Transtech **Bulletin**

Application: Nissan RE4R01A

Subject: New Extension Housing Seal Pathfinder 2WD

TB 2 2/00

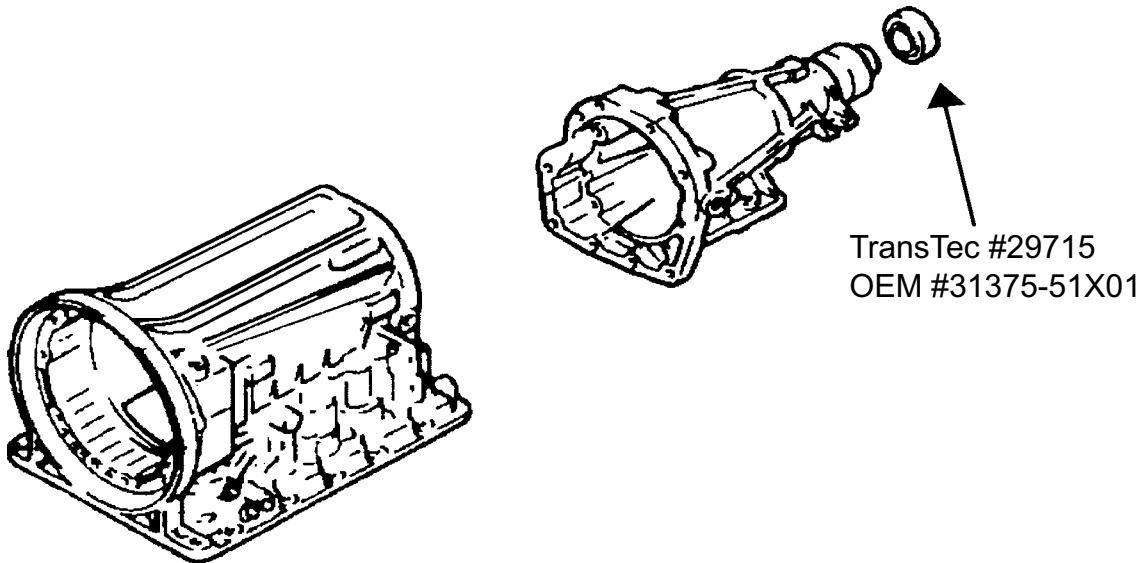
1999-up Nissan Pathfinders with 2-wheel drive use a new extension housing seal. The seal along with the bushing and drive shaft yoke was made larger to accommodate more torque. This seal will be offered in bulk only under part number 29715 (OEM #31375-51X01). This seal is made by NOK.
